North Carolina State University
School of Engineering

Docket No. 50-297
Facility License No. R-120

Ref: 26 July 1984 Request for Technical Specifications Changes.

Subject: Proposed Revisions to the PULSTAR Technical Specifications.

NUCLEAR REACTOR PROGRAM ORGANIZATIONAL CHART

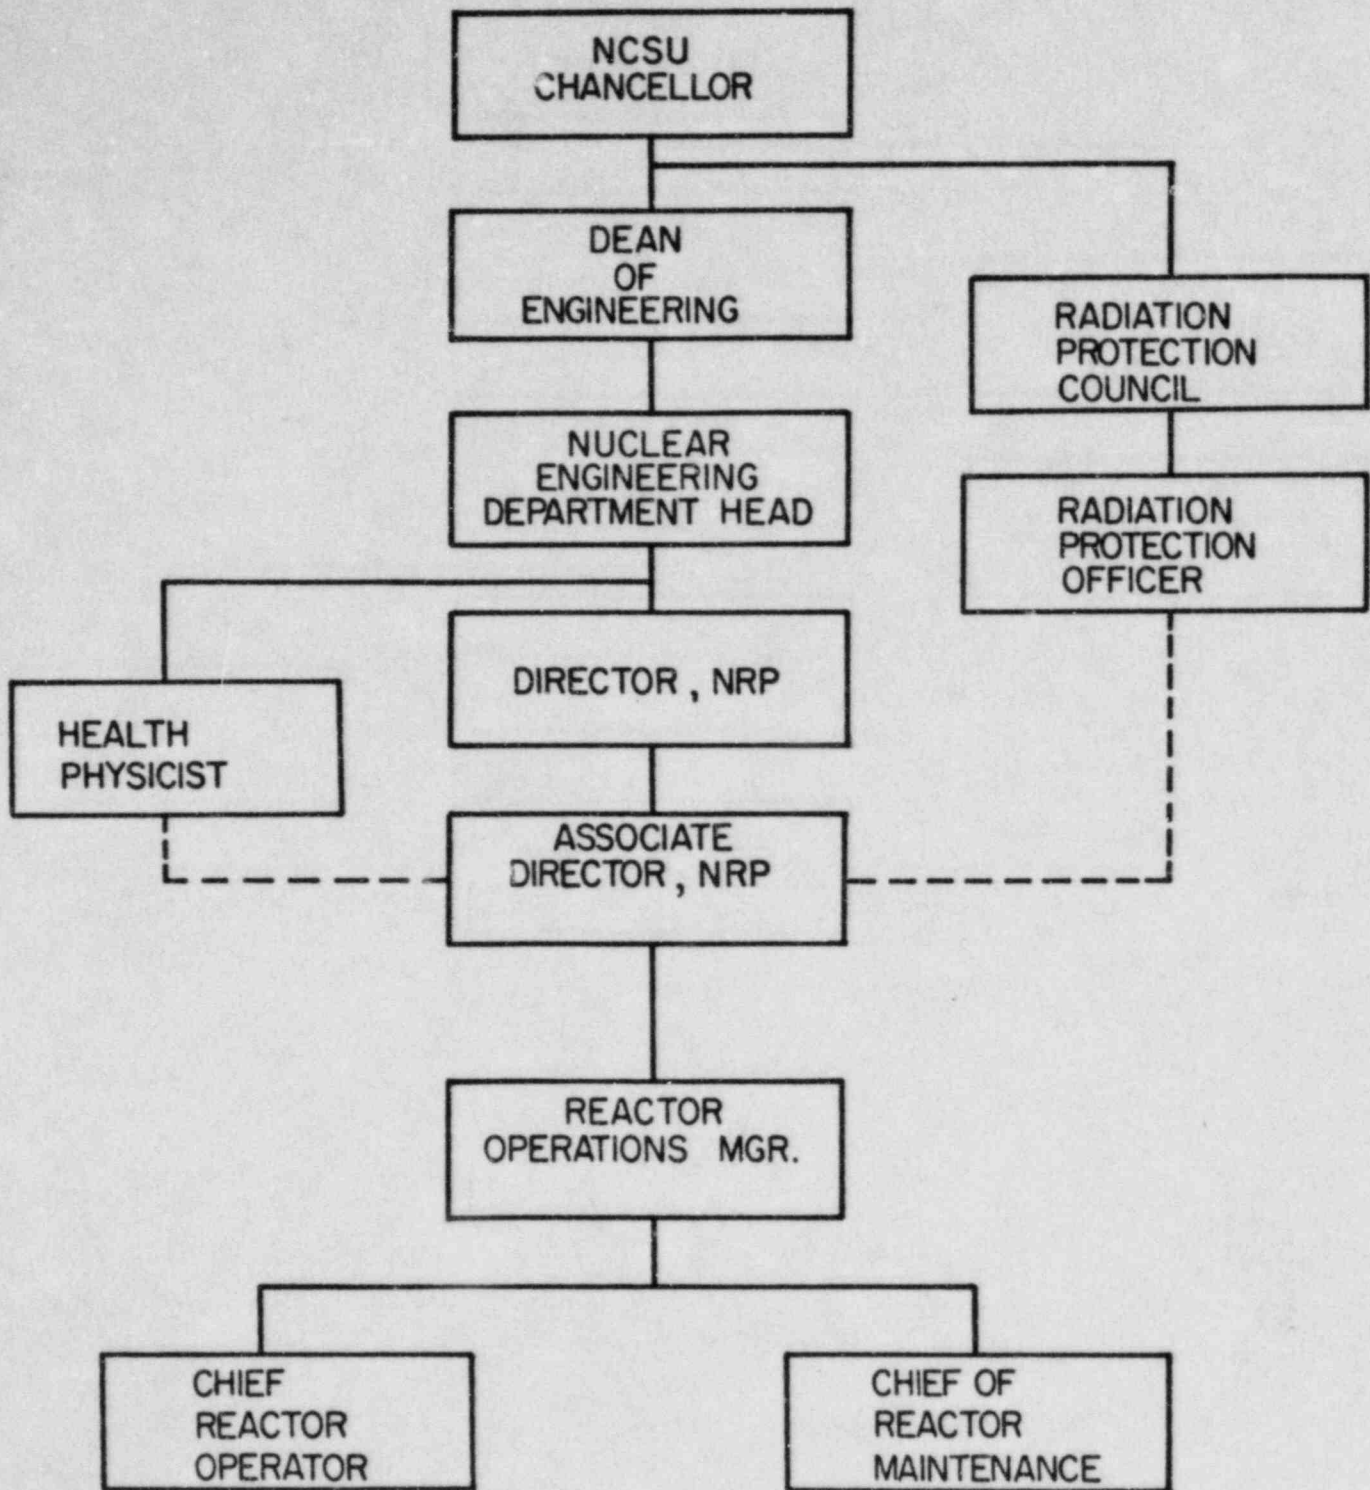
(32)	37	Figure 6.1-1	Safety analysis consistent with items (27) and (29) above.
(33)	38	6.2.2	<p>The intent of rewriting ¶ 6.2.2 under <u>Review and Audit</u> is twofold: To adhere more closely to the guidelines of ANS-15.1/ANSI N378-1974 and to make editorial changes for the purpose of clarity. All the review and audit features of the original Technical Specifications have been retained while the actual number of separate statements under Para. 6.2.2 have been reduced. All references to "abnormal" occurrences, conditions and operations have been re-edited to categorize these instances as "reportable events", in keeping with ANS 15.1 terminology.</p>
